ALLOCATION PROBLEMS OF SECOND AND THIRD CHANNEL
FM RADIO STATIONS (LPFM) IN THE VICTORIA,
TEXAS, RADIO MARKET

SUBMITTED AS ADDENDUM TO REPLY COMMENTS
IN RM-9242
BEFORE THE
FEDERAL COMMUNICATIONS COMMISSION

FM STATIONS VERSUS LOW POWER FM STATIONS -- LOSS OR GAIN?

ADDENDUM 21

E.R.C.
EXHIBIT (11)

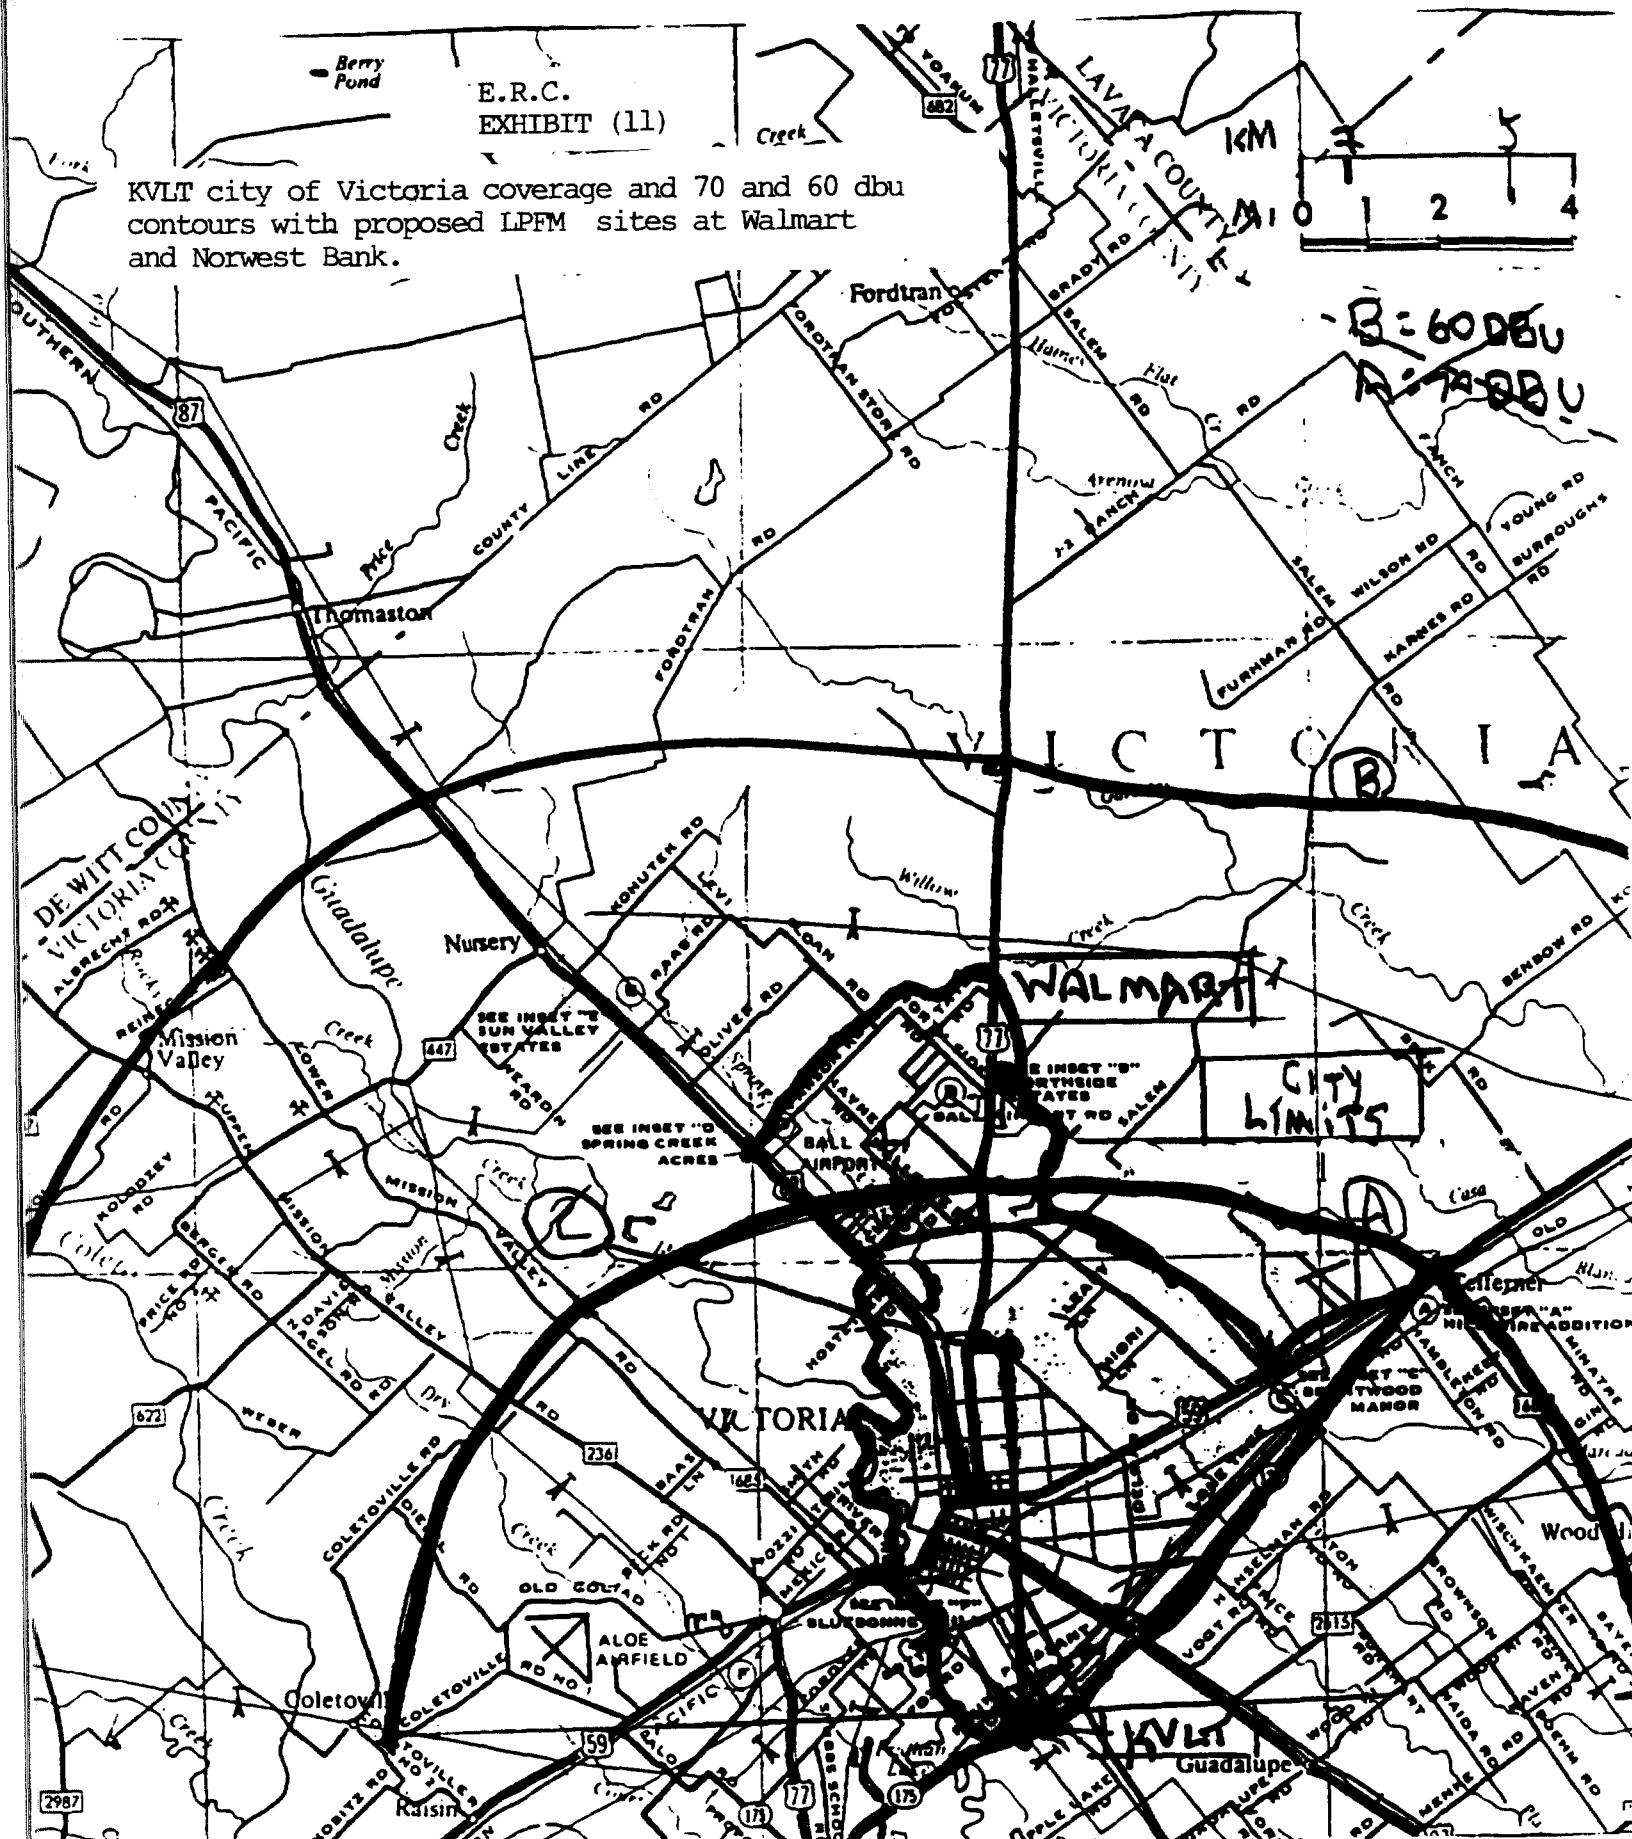
KVLT city of Victoria coverage and 70 and 60 dbu contours with proposed LPFM sites at Walmart and Norwest Bank.

EXHIBIT (12)

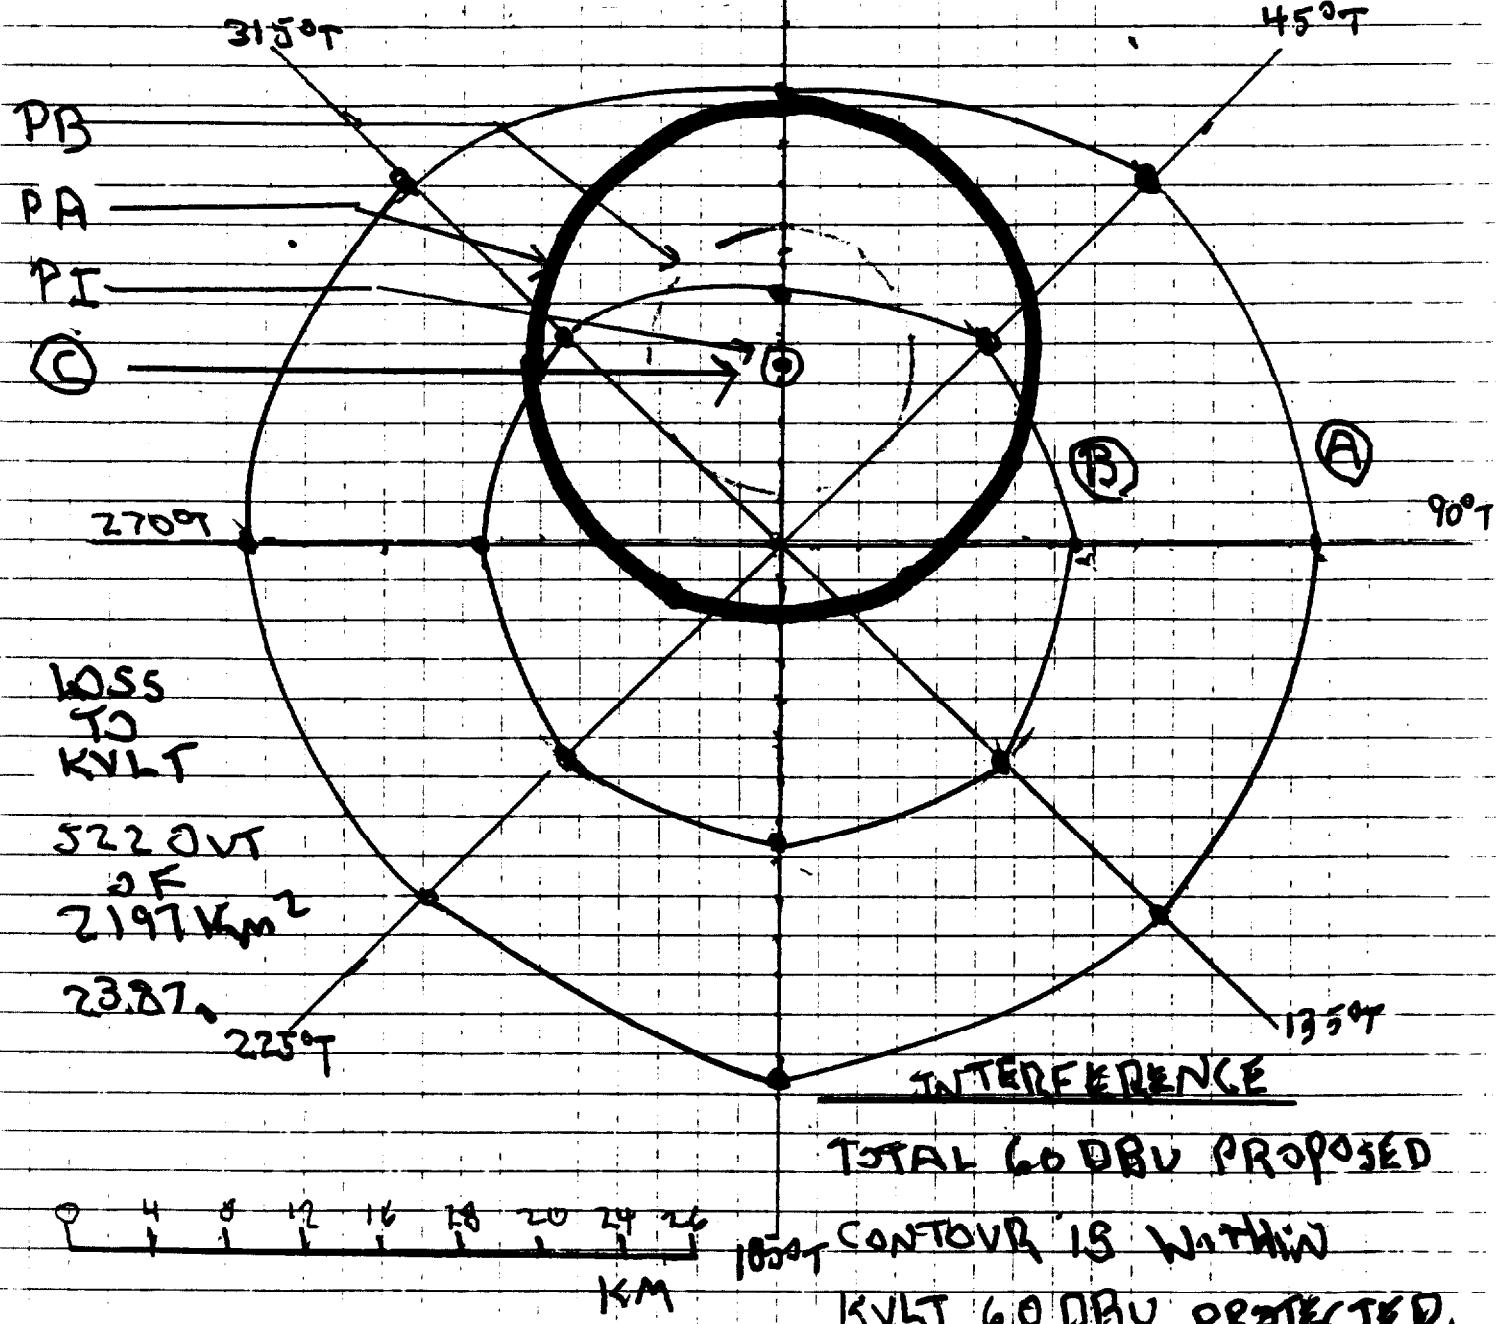
KVLT victim station interference from
Norwest proposed station. ±600 khz.
